PLANNED UNIT DEVELOPMENT
STAFF REPORT

DEVELOPMENT NAME Heron Lakes Subdivision, Phase Two, "Corrected Plat", Resubdivision of Lots 110, 111, and 112

CONTEMPLATED USE Increased Site Coverage of 38% in an R-1, Single-Family Residential District

SITE PLAN

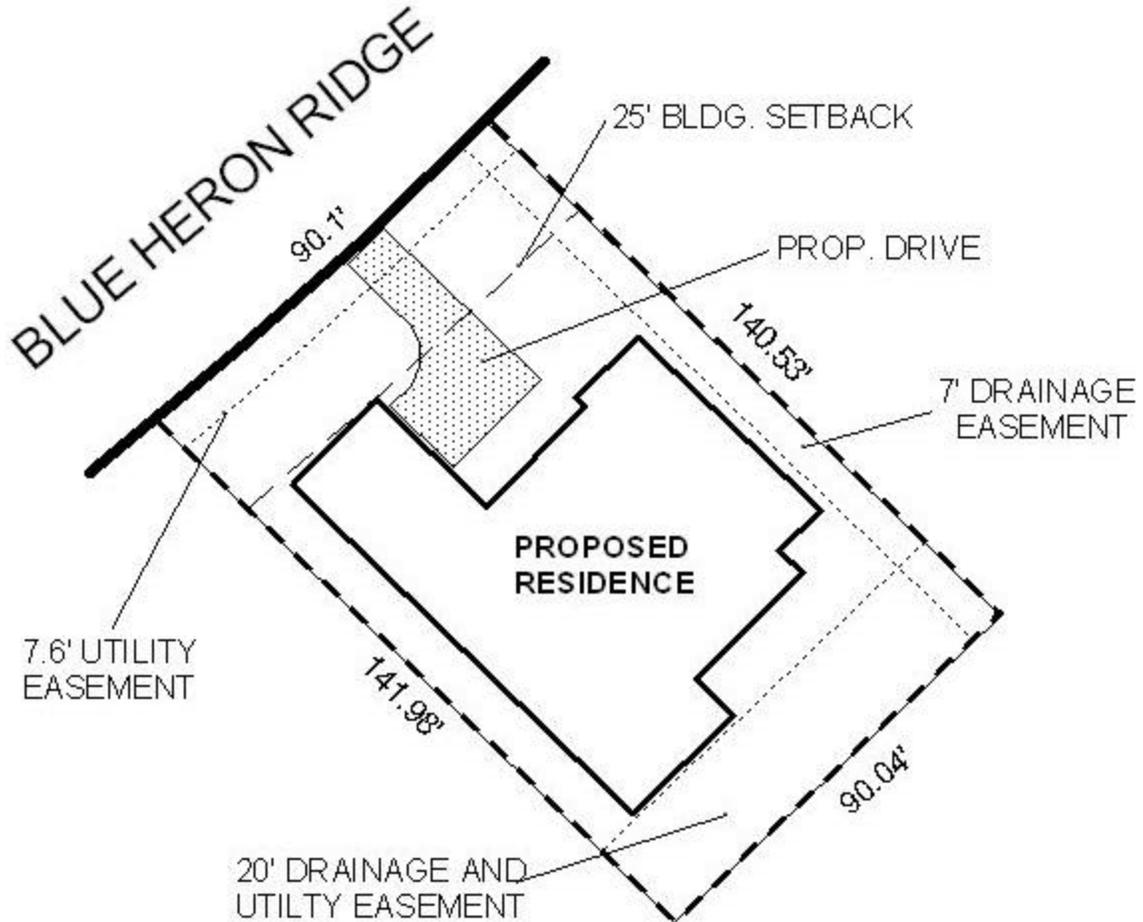
Recommend initial developer provide verification that designed stormwater system and constructed stormwater system are adequate to accommodate increased impervious areas from all submitted requests for increased coverage. Verification should be from professional engineer registered in the state of Alabama. If this is not feasible, each applicant for increased coverage should provide verification that stormwater (designed and constructed) can accommodate increased impervious areas. Must comply with all stormwater and flood control ordinances. Any work performed in the right of way will require a right of way permit.

Driveway number, sizes, location and design to be approved by Traffic Engineering and conform to AASHTO standards.

RECOMMENDATION Based upon the preceding, this application is recommended for approval subject to the following condition: 1) full compliance with the Engineering Comments.
